General Product Information

All product equipped with Dana GT 20 Differentials:

Subject: Repair suggestions for Dana Axle Shaft Seal leakage conditions.

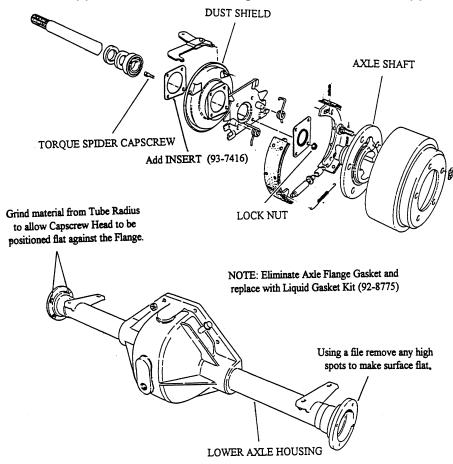
- 1. The head of the Torque Spider Capscrew must be positioned flat against the Axle Flange. To accomplish this, grind any material from the Axle Tube radius that interferes with the edge of the cap screw head.
- 2. The outside surface of the Axle Flange must be flat. Use a file to correct any high areas.
- 3. Eliminate the Axle Flange Gasket and replaced with Liquid Gasket Kit (92-8775).
- 4. Add metal Insert (93-7416) between the Dust Cover and the Axle Flange. This Insert will provide additional support to the Axle Bearing for extreme side hill applications.
